Status: Y N U **Area Walk-By Checklist (AWC)**Location: Bldg. DIESEL Floor El. 130 Room, Area¹ SWITCHGEAR ROOM 2F**Instructions for Completing Checklist**

Status: Y N U **Area Walk-By Checklist (AWC)**Location: Bldg. REACTOR Floor El. 87 Room, Area¹ Unit 2 HPCI Room**Instructions for Completing Checklist**

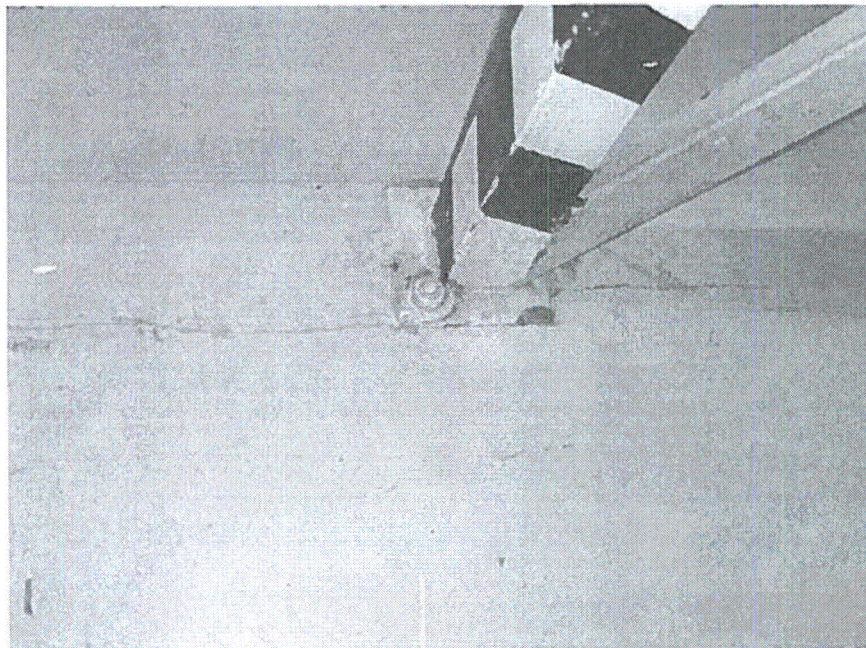
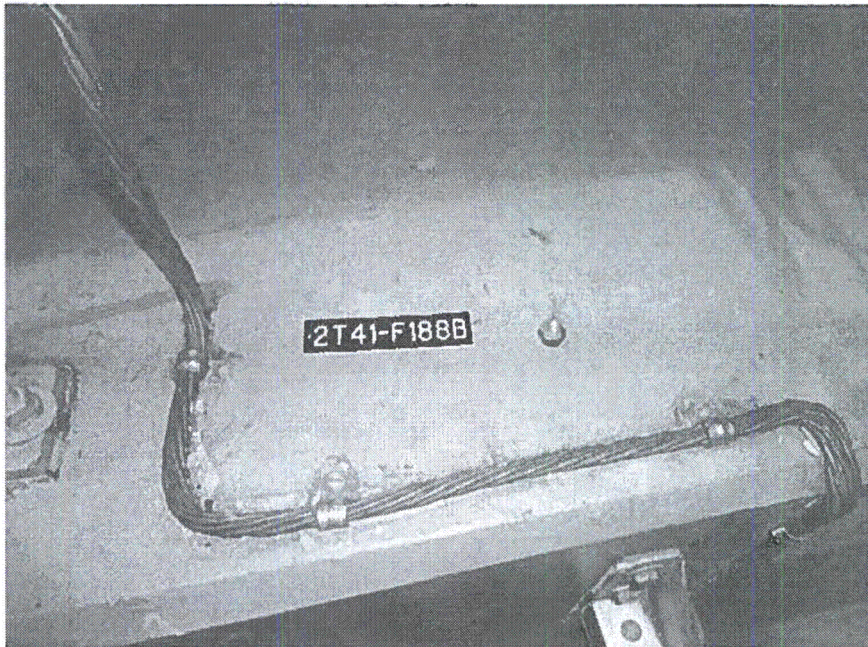
2. Does anchorage of equipment in the area appear to be free of significant degraded conditions? Y N U N/A
Filter Train 2T41-D007 and D008 have anchor bolts corroded as shown in the attached pictures. The corrosion appears to be severe enough to degrade the capacity of the some of the bolts. A CR has been initiated for this purpose (CR515661).
Support anchors on the floor for the exhaust fan (2T41-C005B) ducts have cracks in the concrete at one of the anchor bolts. See attached pictures. A CR has been initiated for this purpose (CR515779).

A loose tag was found in the room. A CR has been initiated for this purpose (CR515431). See attached picture.

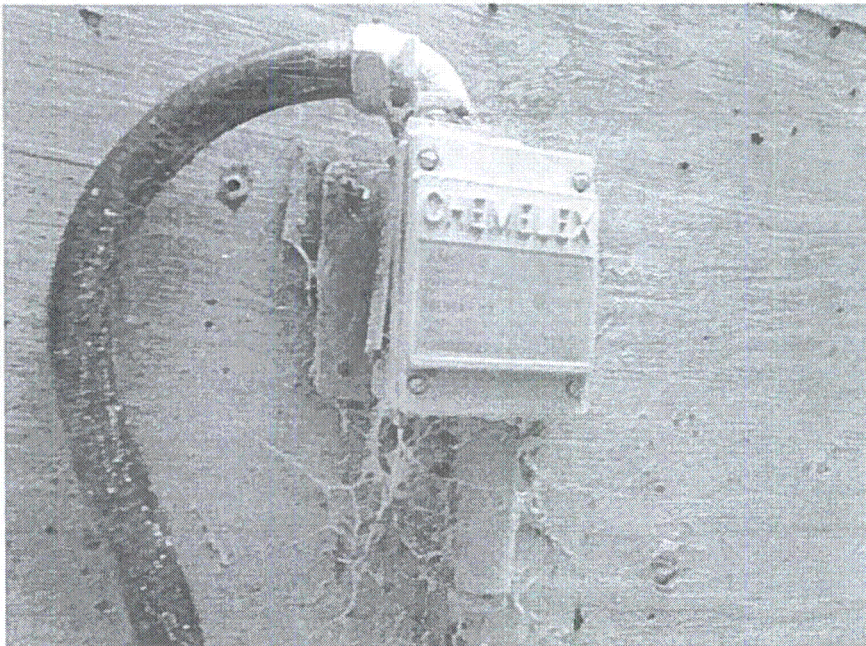
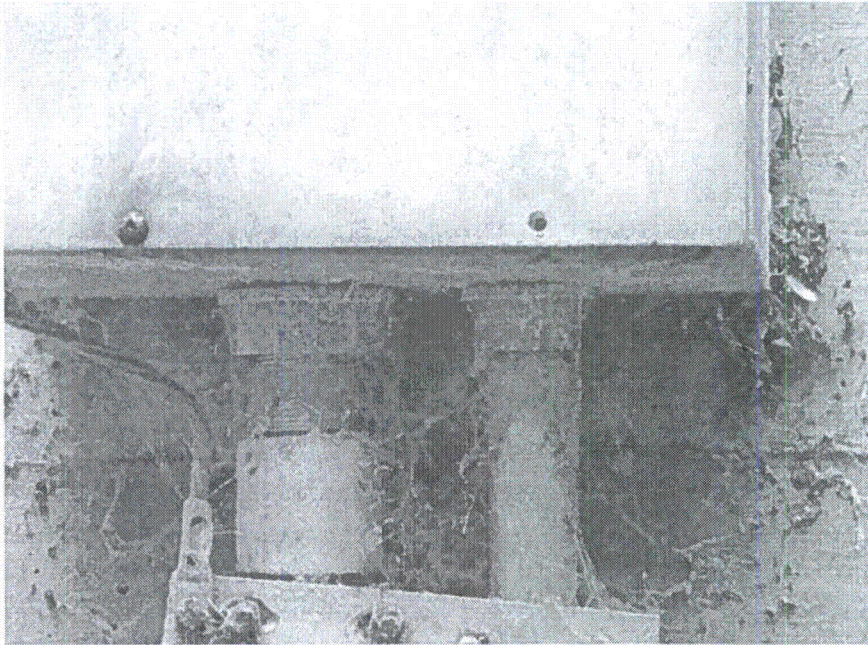
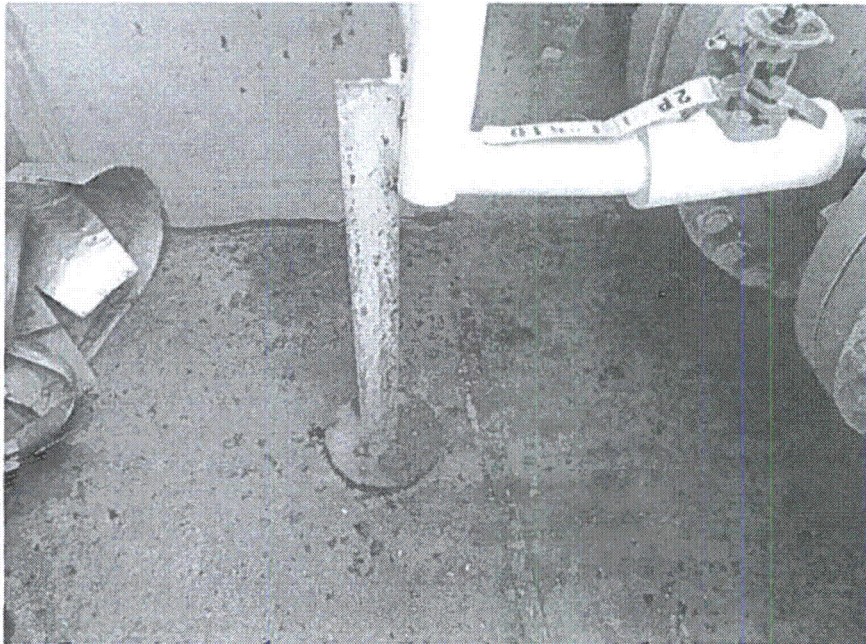
1. Does anchorage of equipment in the area appear to be free of potentially adverse seismic conditions (if visible without necessarily opening cabinets)? Y N U N/A
A missing screw was observed on the front cover of the splitter box and also on the Chemelex box support to the wall. SWEs judged these not to be potentially adverse seismic conditions. However, CR525473 was initiated to replace these screws.

2. Does anchorage of equipment in the area appear to be free of significant degraded conditions? Y N U N/A
Widespread corrosion was also observed in this pit. SWEs judged this not to be a potentially adverse seismic condition. However, CR525475 was initiated for this purpose.

A broken tag was found on the floor. SWEs judged this not to be a potentially adverse seismic condition. However, CR525476 was initiated to fix this issue.

Figure 1 – Missing U-Bolt (Unit 2 87' NE Diagonal)

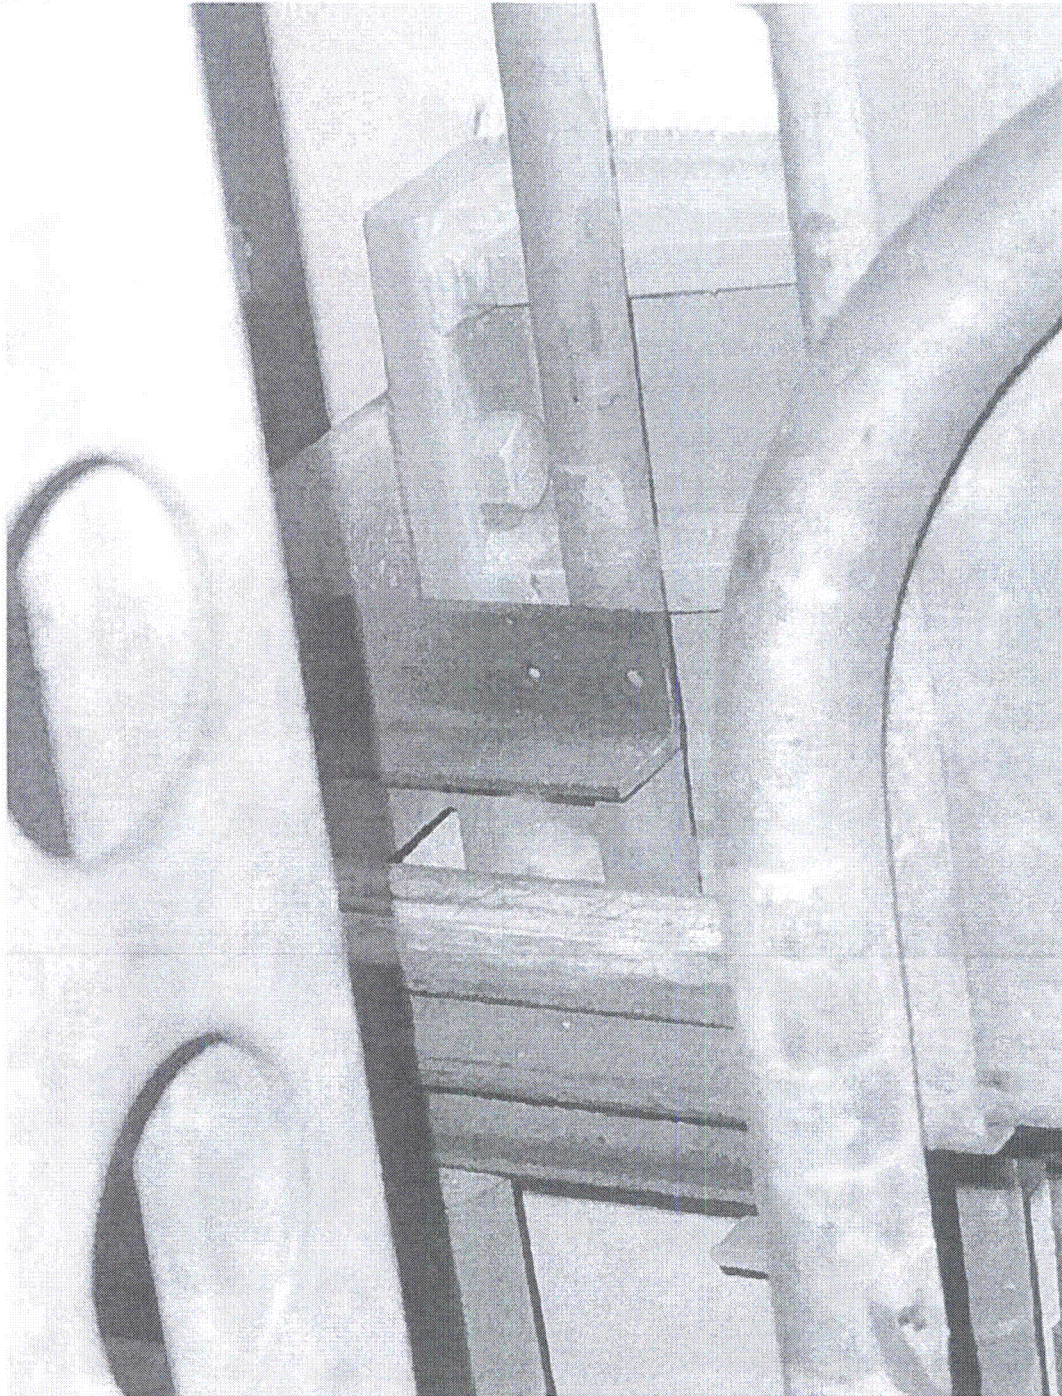
2. Does anchorage of equipment in the area appear to be free of significant degraded conditions? Y N U N/A
3. Based on a visual inspection from the floor, do the cable/conduit raceways and HVAC ducting appear to be free of potentially adverse seismic conditions (e.g., condition of supports is adequate and fill conditions of cable trays appear to be inside acceptable limits)? Y N U N/A
There was a 1" diameter demineralized water pipe discovered that appeared to be missing a U-bolt (CR 523085). There is an angle with two holes drilled in it immediately adjacent to the pipe above the 2H21-P001 instrument rack that looks like it was intended as a pipe support. The pipe has additional supports on either side of the missing support and is light, so it is judged that the existing supports have adequate capacity to support the pipe. Therefore, there is no potentially adverse seismic condition. However, the missing support needs to be reinstalled.

Figure 2 – Temporary Power Cord (Unit 2 87' NE Diagonal)

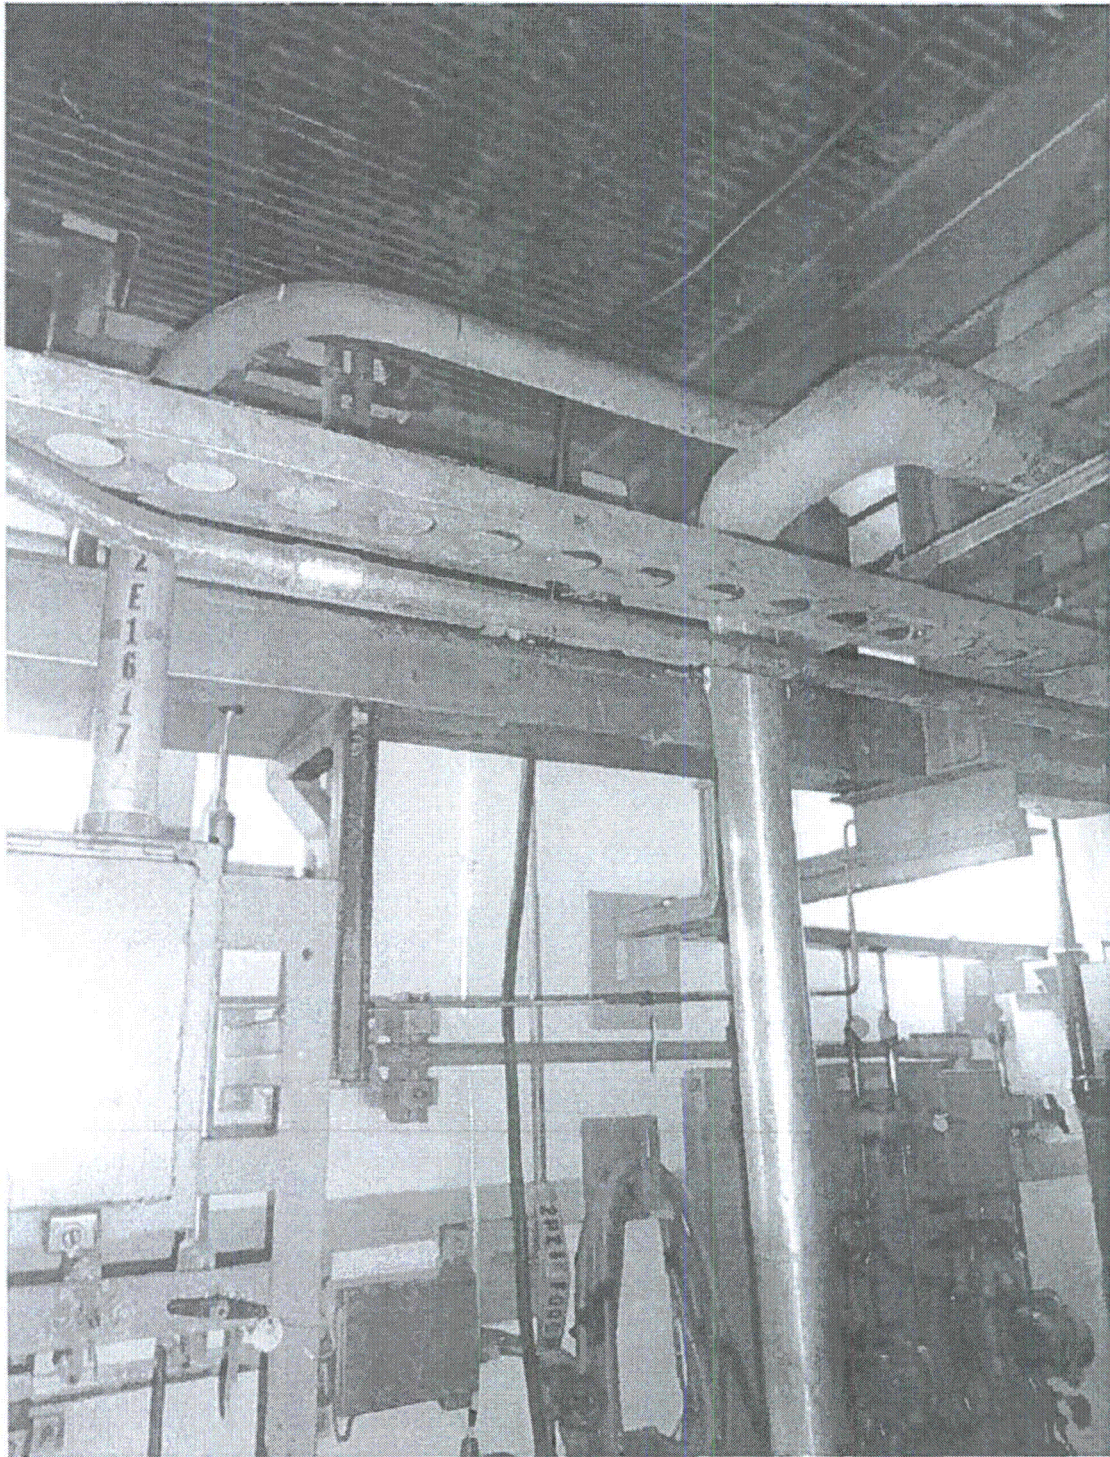
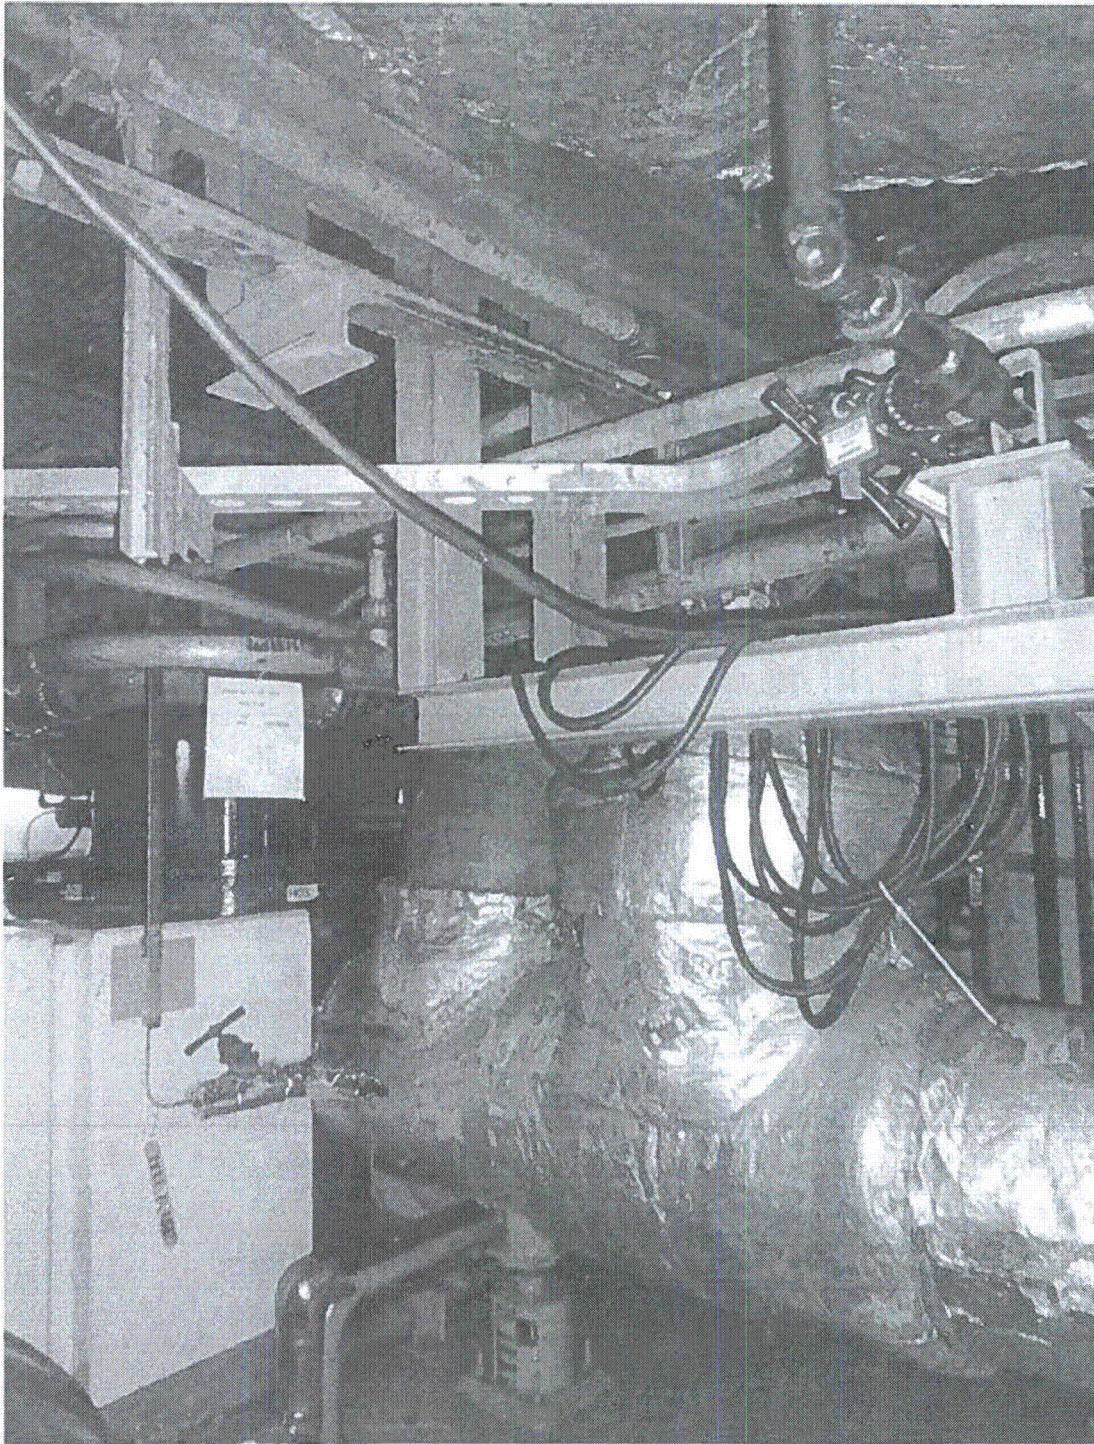
4. Does it appear that the area is free of potentially adverse seismic spatial interactions with other equipment in the area (e.g., ceiling tiles and lighting)? Y N U N/A
There is a temporary power cord strung along the building steel to the 2E11-C002A RHR Pump. The bulk of the power cord is tied into a loop near a steel beam, which is judged sufficient to prevent impact between the cable and any sensitive equipment on the other side of the beam. Therefore, there is no potentially adverse seismic interaction.

Figure 5 – Loose Items in Contaminated Area (Unit 2 87' NE Diagonal)

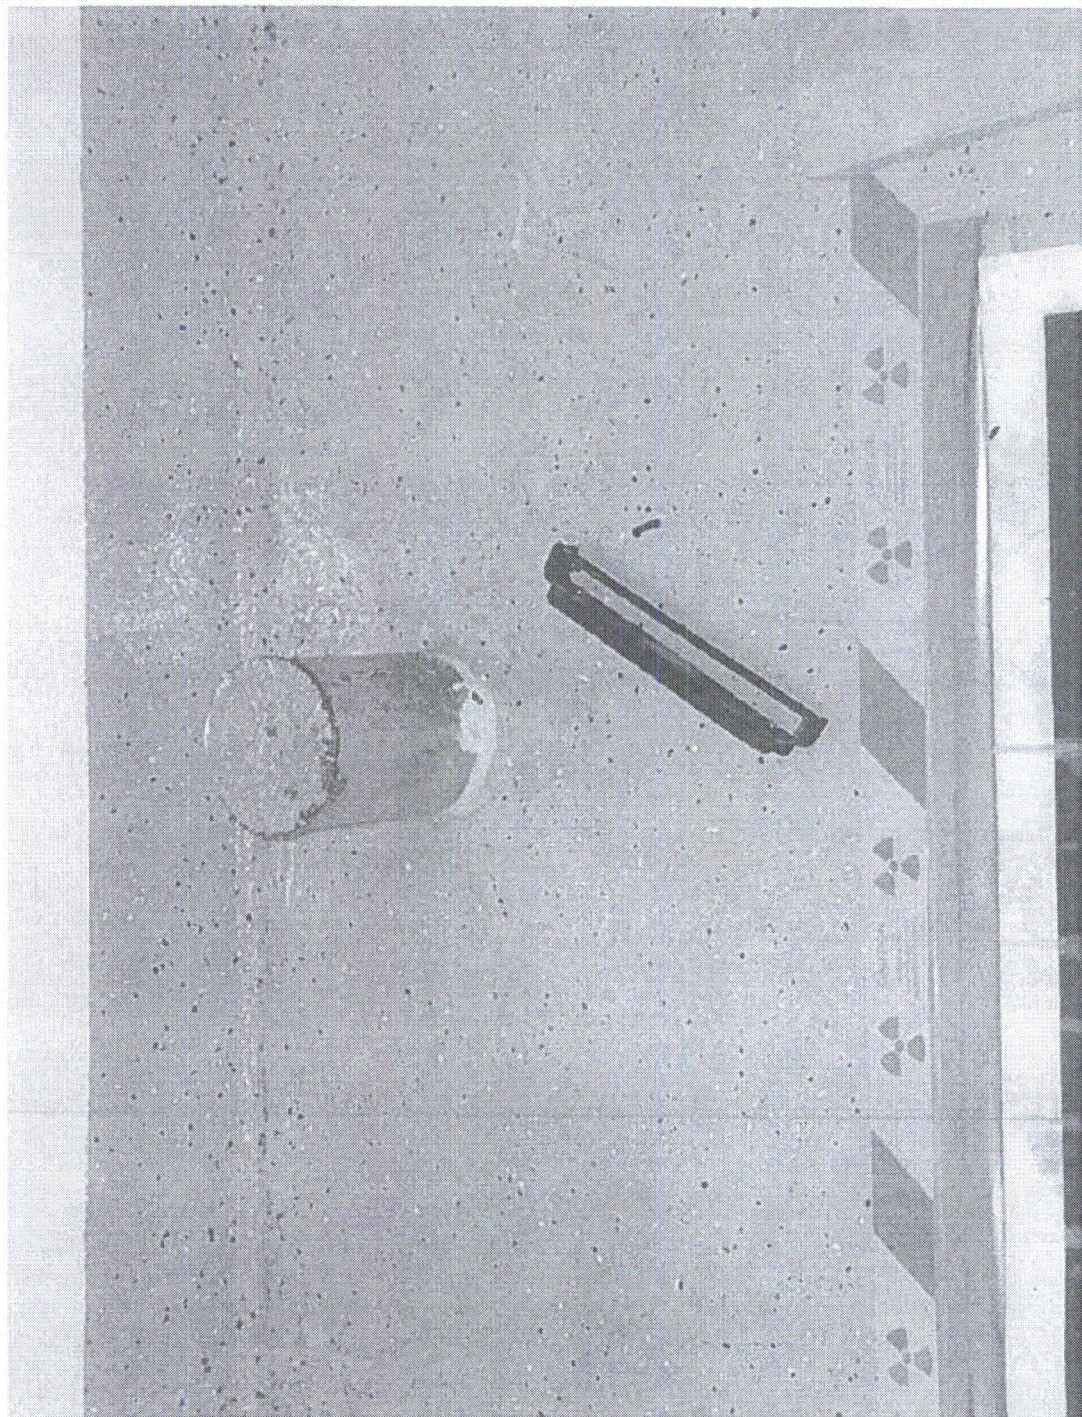
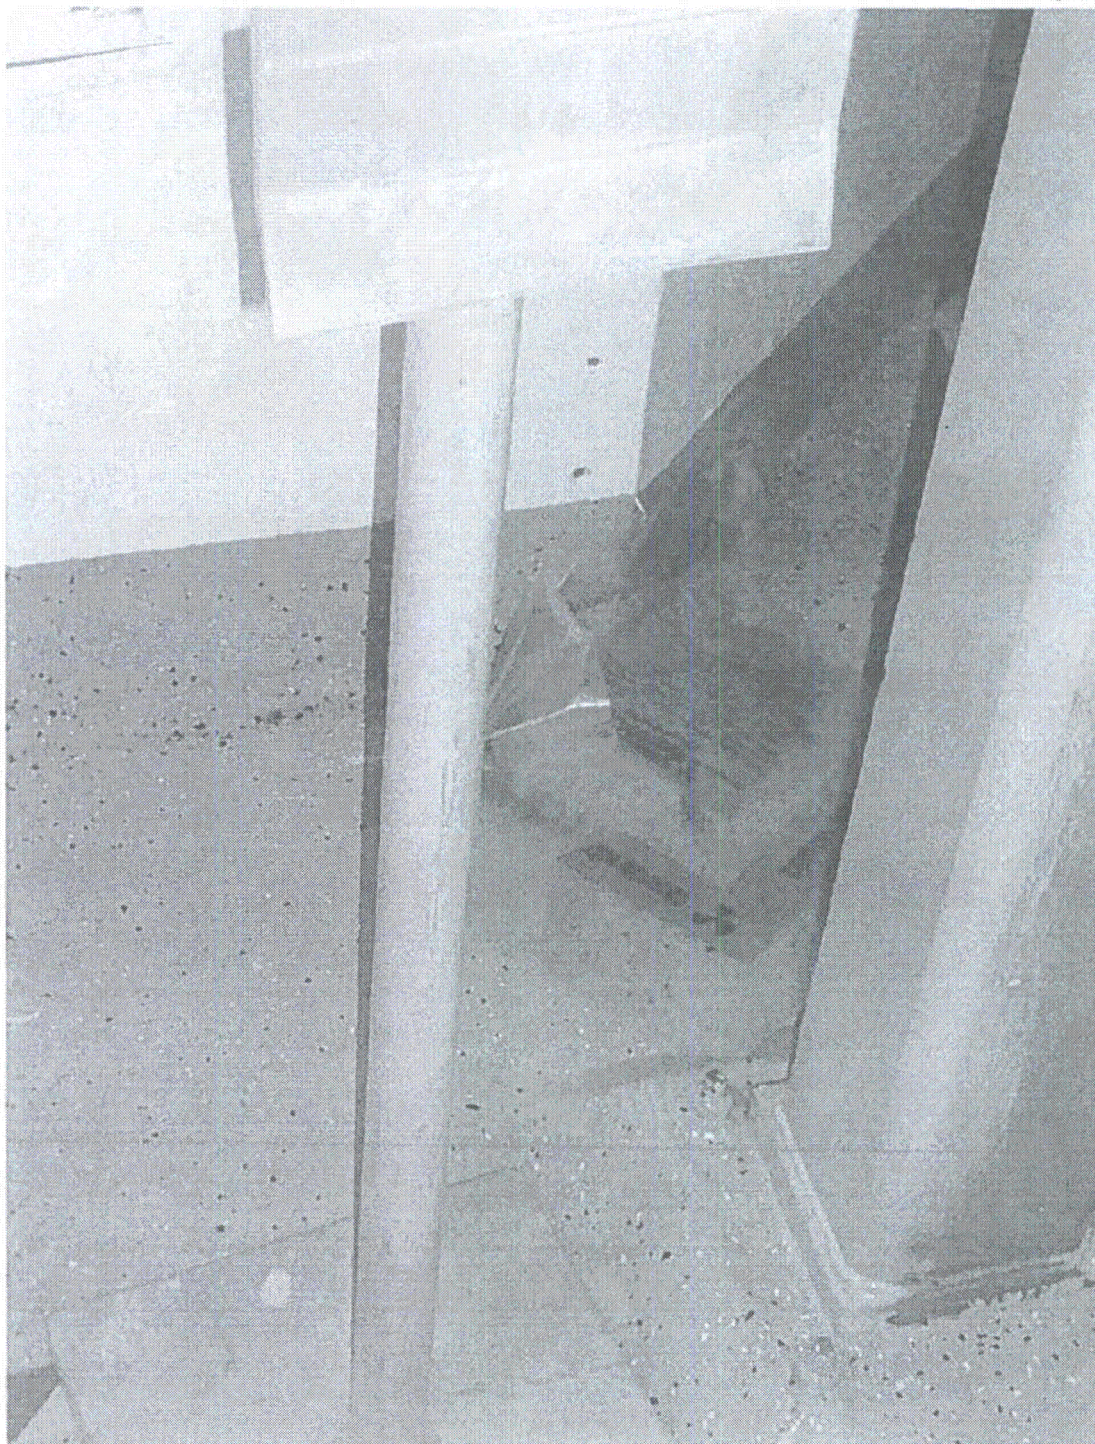
There are a few items (a plastic bag, a roll of caution tape and a small metal piece) left loose in the contaminated area around the 2E11-C002C RHR Pump. All of the items are small and light and located away from sensitive equipment, so are judged to not create a potentially adverse seismic condition.
